To: Russ Means and Tim Cazier (DRMS) 4122A
Glen Williams (Cotter Corporation, N.S.L.)
From: Susan Wyman, P.E., P.G. (Whetstone Associates)
Date: July 18, 2012
Subject: Response to DRMS Adequacy Review #2
Additional Stormwater Control Structure for JD-8 Mine

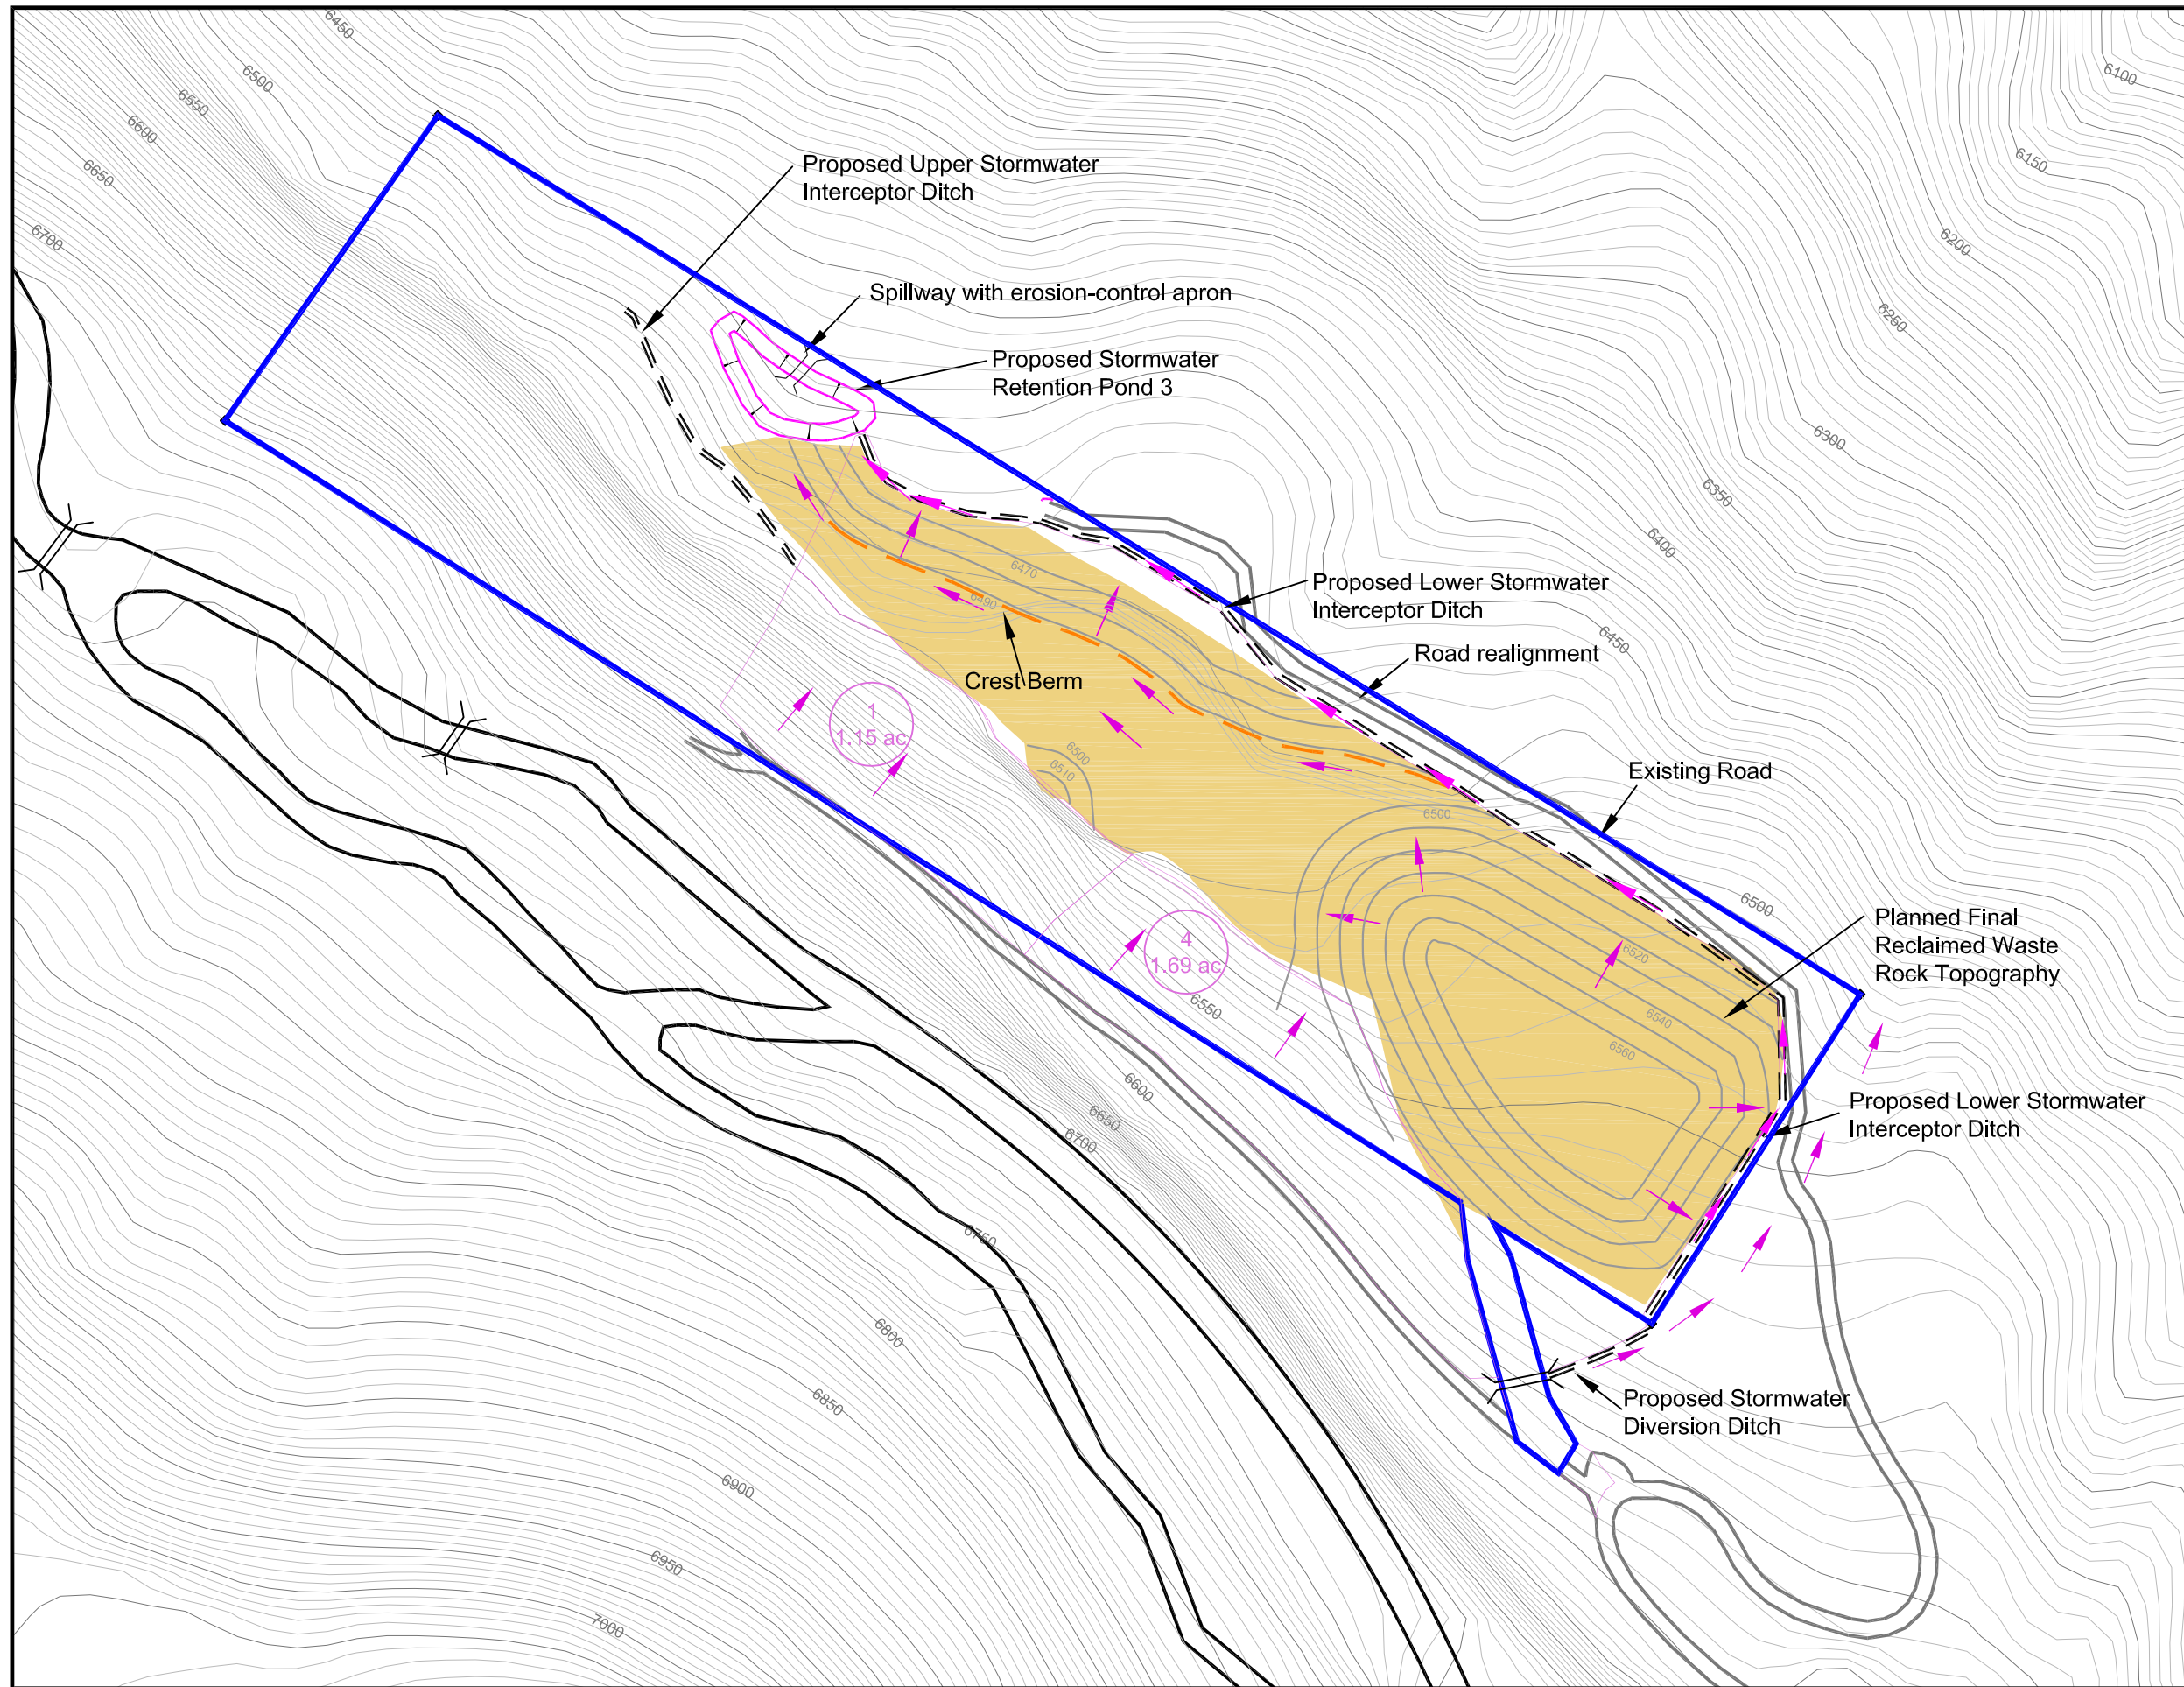
The revised Drainage Design Plan for the JD-8 Mine was prepared on July 3rd 2012 and submitted to the Division of Reclamation, Mining and Safety (DRMS) as part of Cotter Corporation (N.S.L.) (Cotter) response to Adequacy Review #2. The DRMS engineering staff reviewed the Drainage Design Plan and requested additional information about the post-mining drainage design in a letter from Tim Cazier to Russ Means dated July 16, 2012.

In response to the DRMS engineering review, an additional post-mining stormwater control structure is proposed for the JD-8 Mine. A new diversion ditch is proposed to divert non-contact stormwater that passes under the existing mine access road through an existing culvert away from the waste rock pile and Lower Stormwater Interceptor Ditch. The new proposed diversion ditch will be angled at approximately 70 degrees (N70E) from the culvert to southeast corner of the Doagy claim boundary. From the corner of the claim boundary, stormwater runoff would flow toward the natural existing drainage. The slope of the final diversion ditch will be evaluated during construction. If the slope on segments of the final constructed ditch are steep enough to require armoring based on the criteria specified in the Drainage Design Plan, then rock armoring will be installed.

Additional measures to prevent this non-contact stormwater from entering the Lower Stormwater Interceptor Ditch will include construction of the ditch as a ditch/berm system, with spoils from the interceptor ditch banked or bermed on the east side to prevent the entry of non-contact stormwater from the natural drainage.

The revised Figure 3 from the Drainage Design Plan is attached.
